Edwin I. Hatch Nuclear Plant  
Request to Revise Technical Specifications:  
Pressure and Temperature Limits

Page Change Instructions

Attachment 1 to Enclosure 3

Marked-Up Pages

Figure 3.4.9-1 (page 1 of 1)  
Pressure/Temperature Limits for  
Inservice Hydrostatic and Inservice Leakage Tests

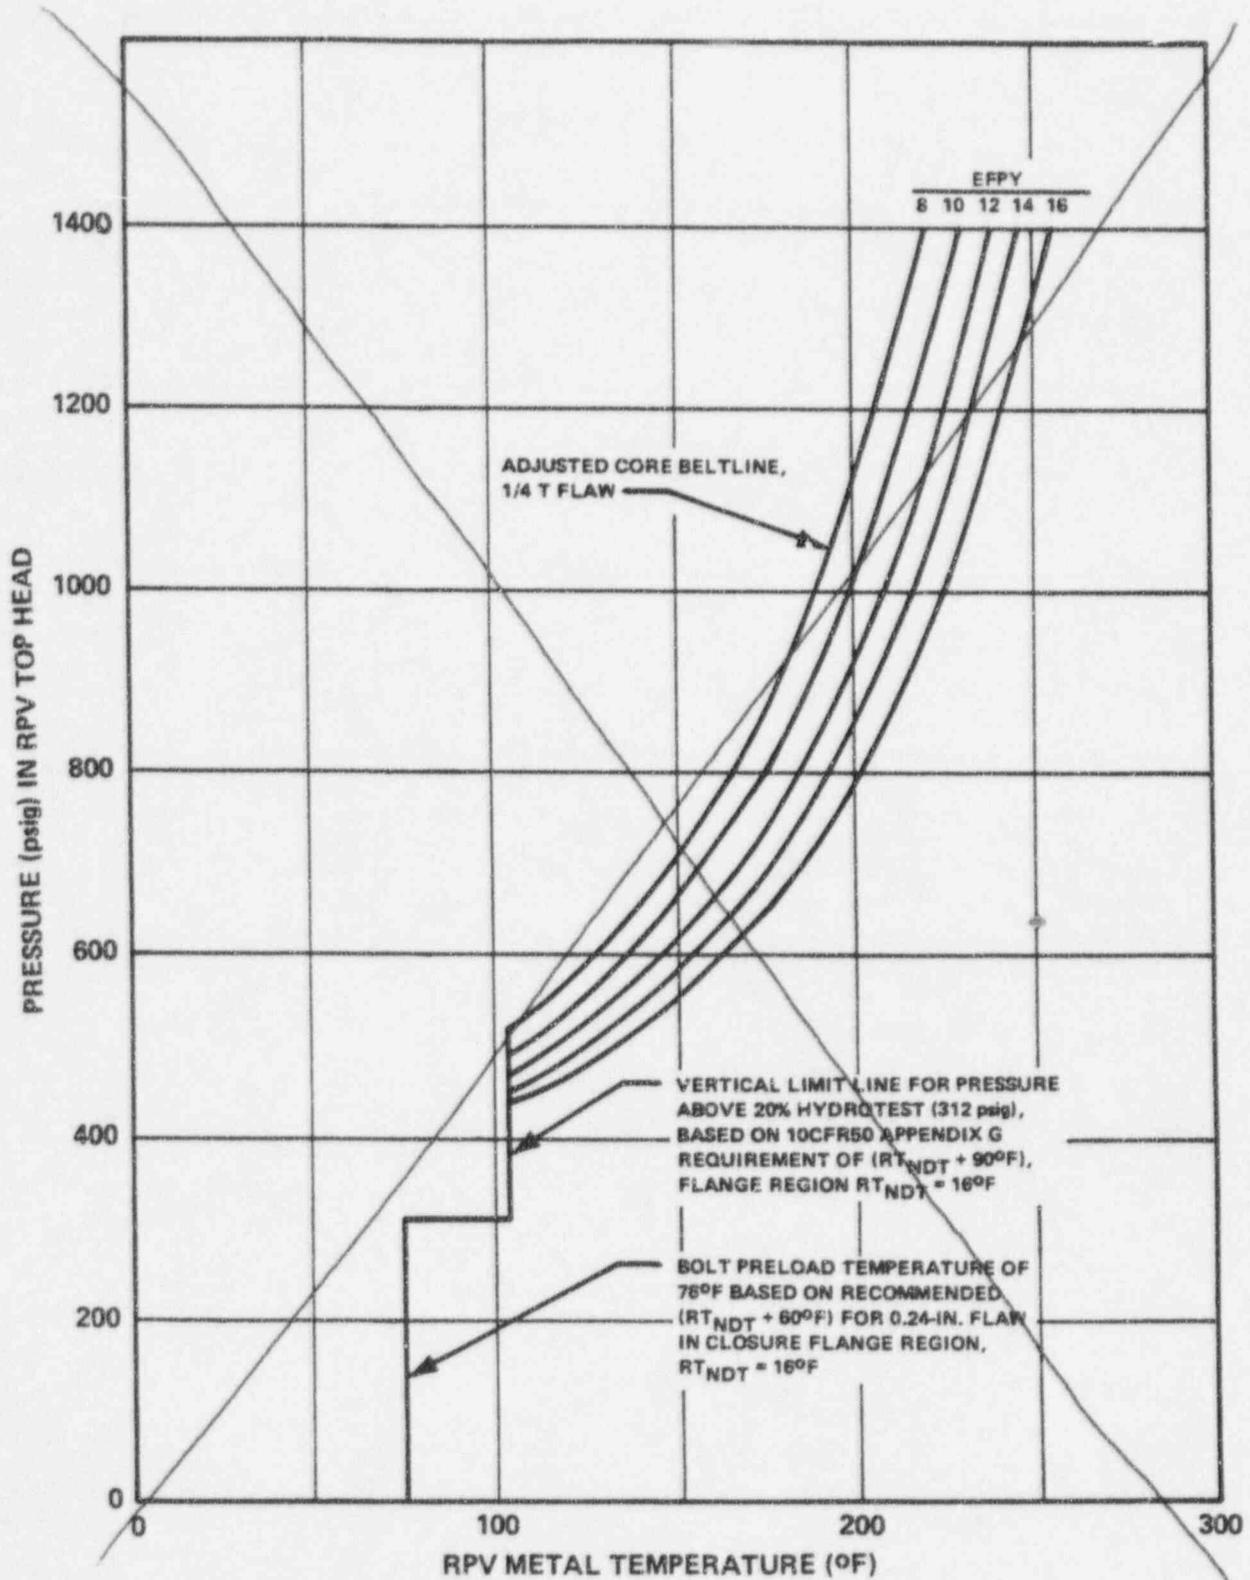
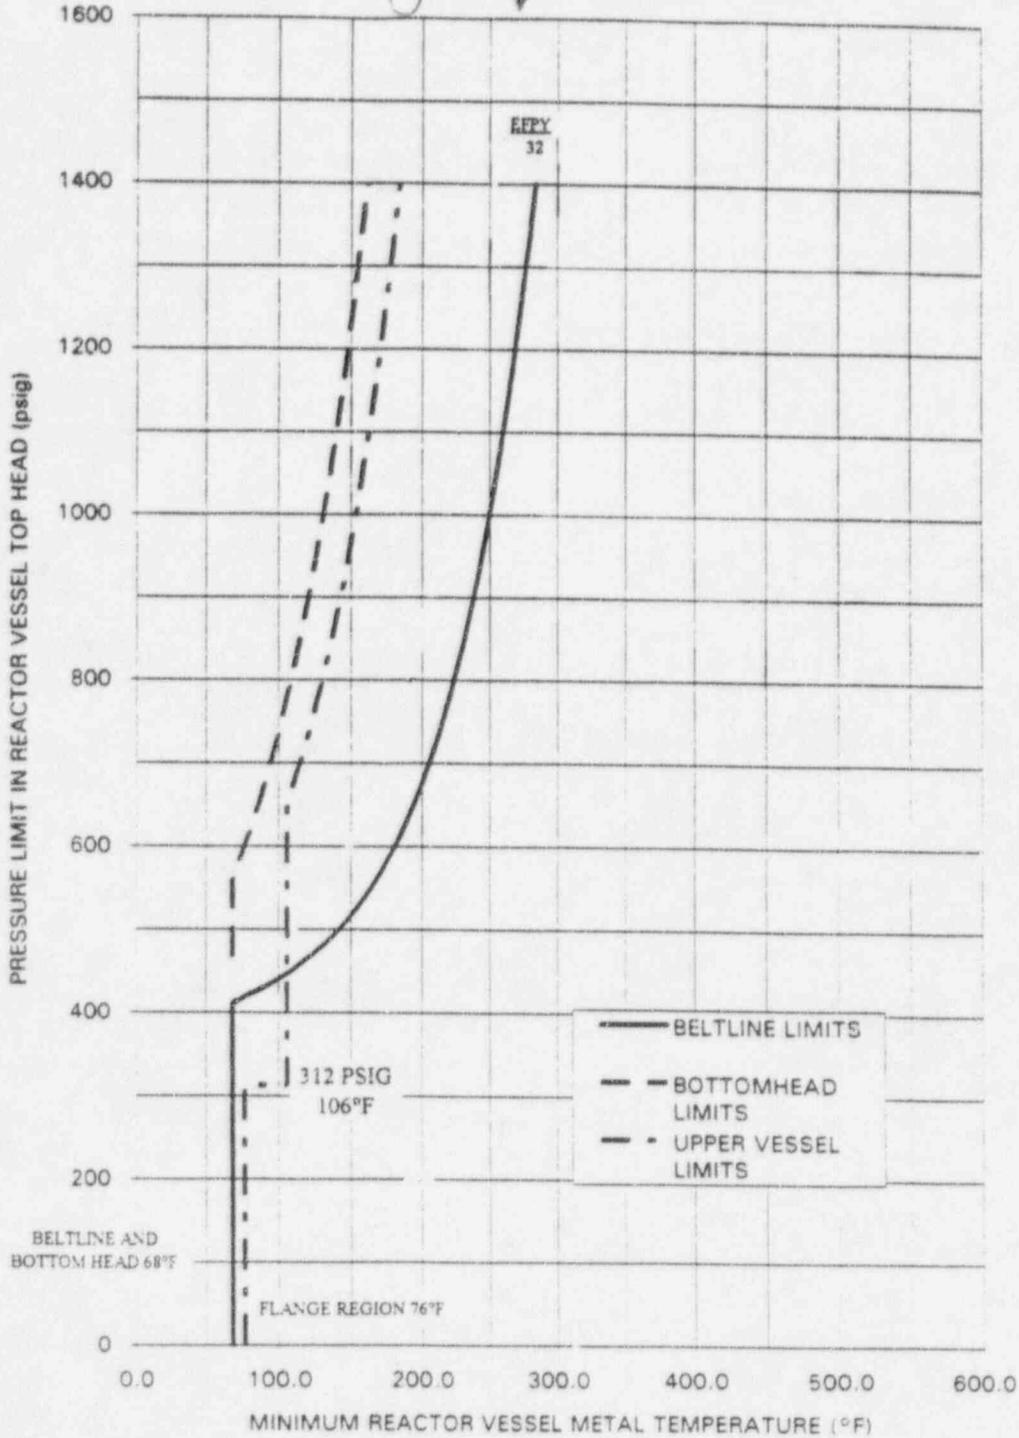
Replace with  
attached  
figure

Replace current Figure 3.4.9-1 (page 1 of 1)  
with this figure ↓

Figure 3.4.9-2 (page 1 of 1)  
Pressure/Temperature Limits for Non-Nuclear Heatup,  
Low Power Physics Tests, and Cooldown Following a Shutdown

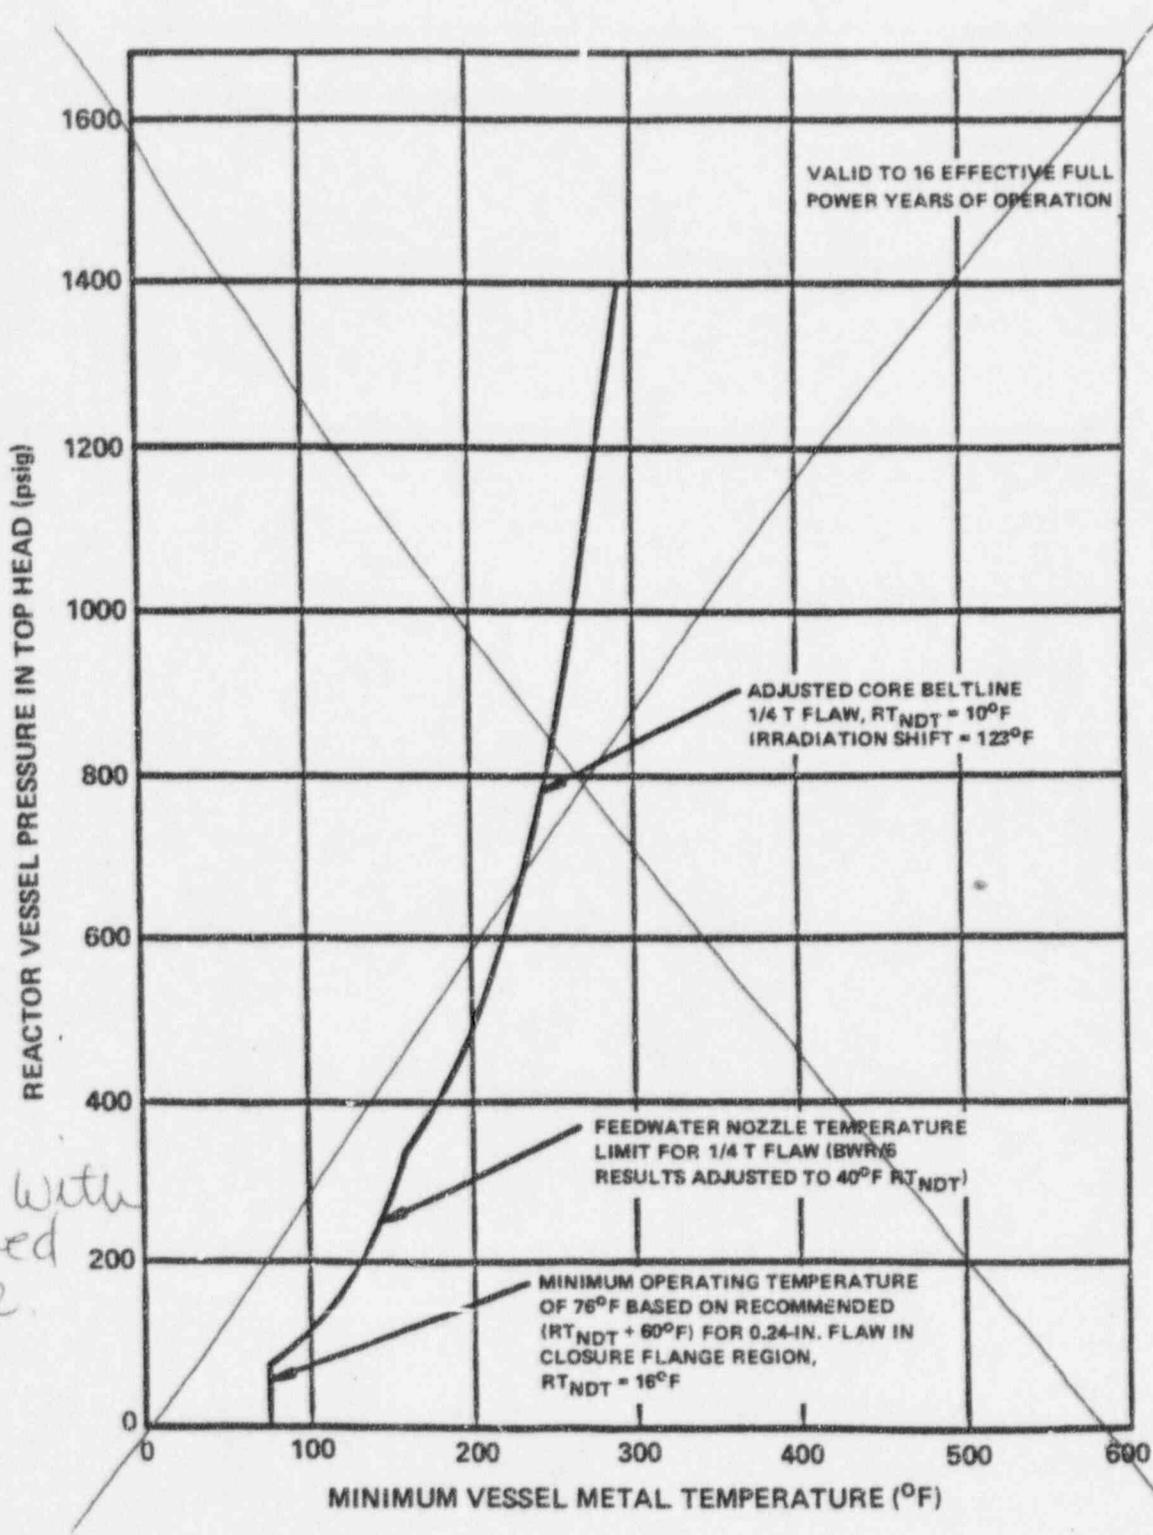
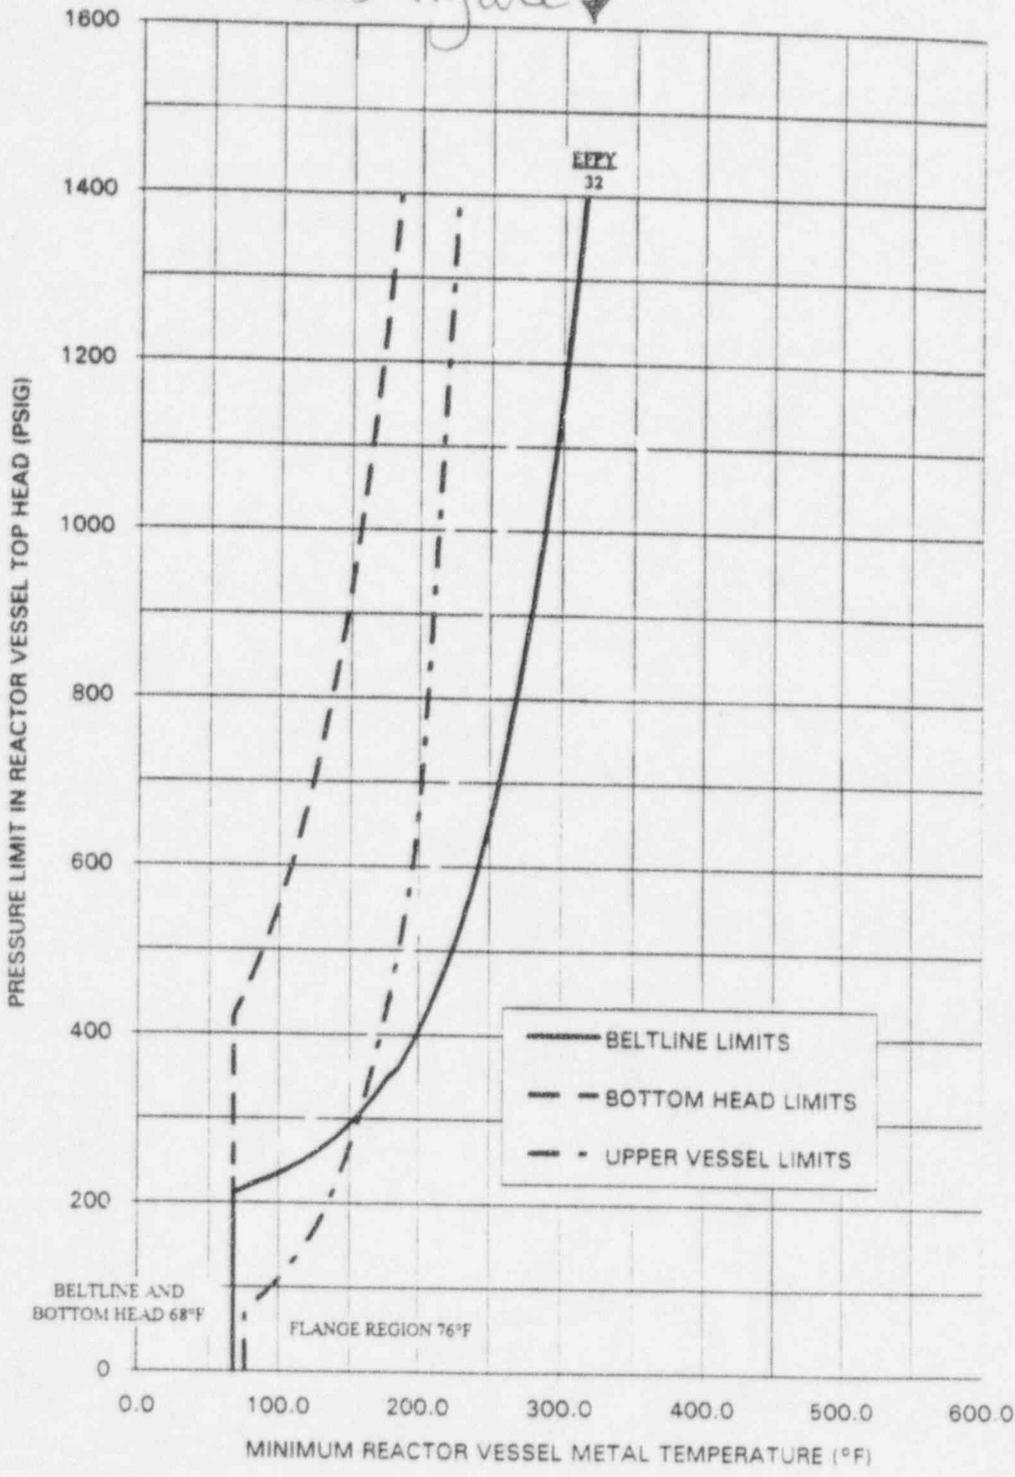
Replace current Figure 3.4.9-2  
with this figure ↓

Figure 3.4.9-3 (page 1 of 1)  
Pressure/Temperature Limits for Criticality

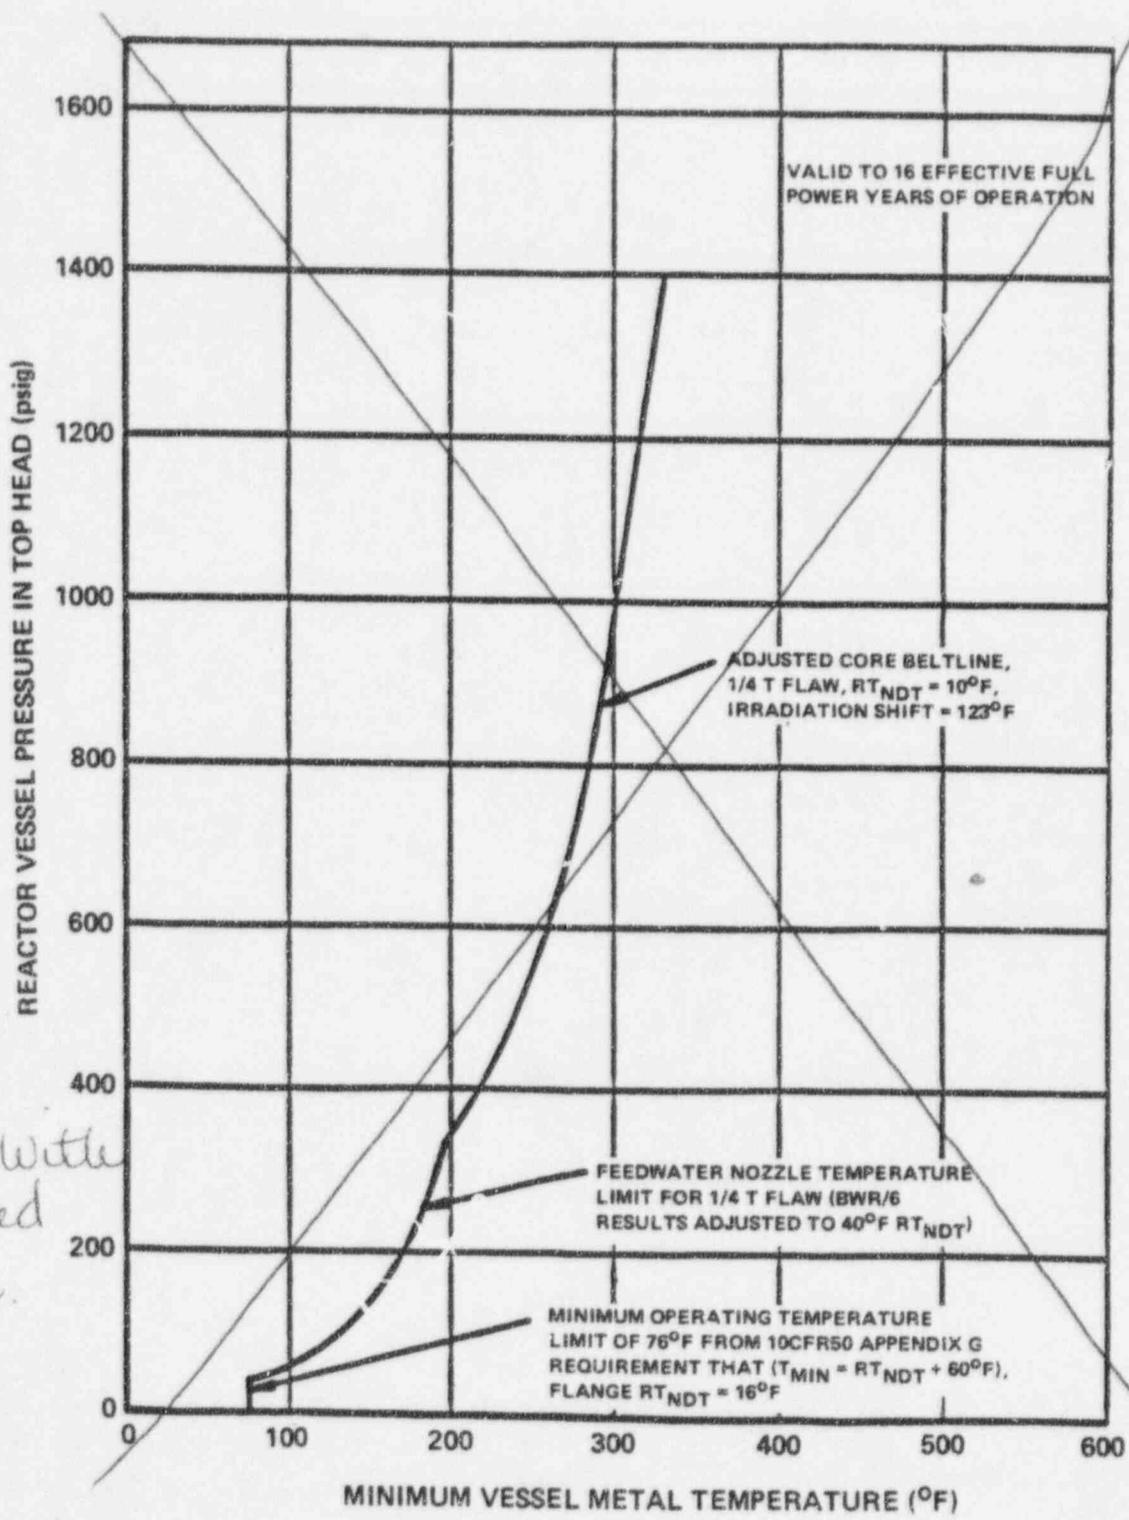
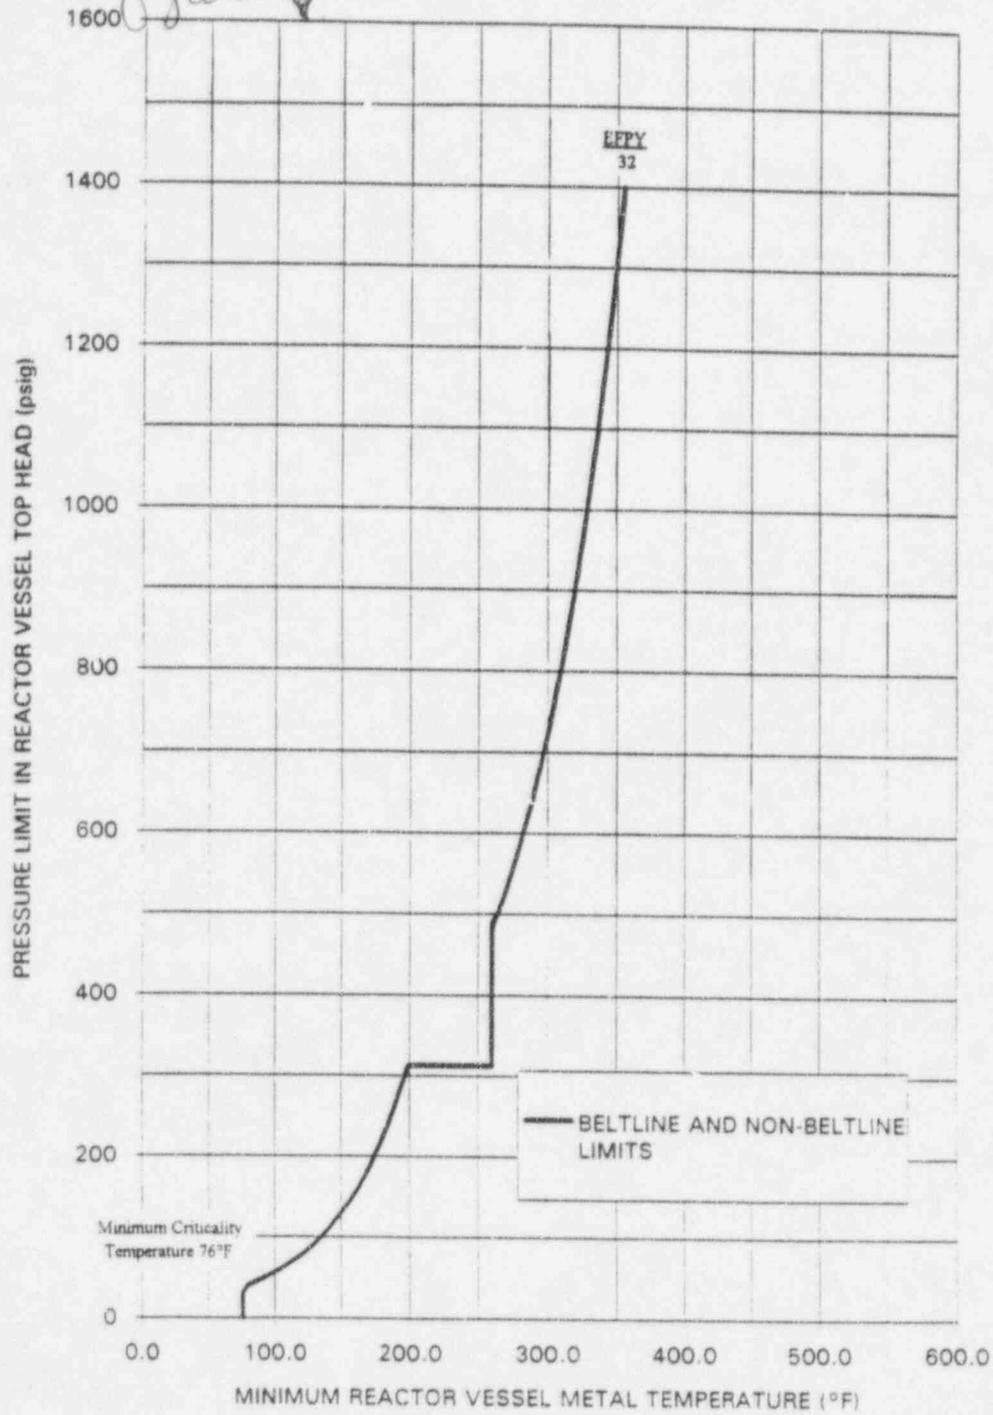
replace with attached figure.

Replace current Figure 3.4.9-3 with this figure ↓
